Customer Safety Advisory Notice
CAN 011-2017

Re: Update - Biograph mCT and Biograph mCT Flow Light Marker Window

Figure 1

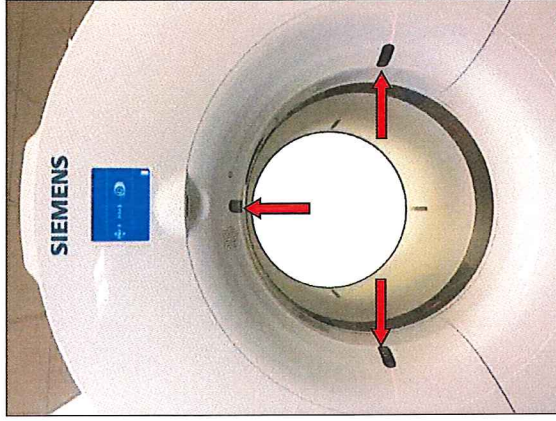
We informed you that the light marker windows (see Figure 1) used for the positioning laser and integrated into the front cover of your Biograph mCT or Biograph mCT Flow system may loosen and potentially drop out. In this case there is a risk that a person could touch the electrical or rotating parts of the gantry in the unlikely event that they reach through the window opening. This could result in a serious injury such as, electrical shock or physical harm.

Through the upcoming field action update, MI513/17/S we will remove and replace the mounting hardware of the light marker windows on your system(s). The glued windows will be replaced with new light marker windows that contain a clip design solution that is more reliable and cannot drop out, unless excessive external force is applied.
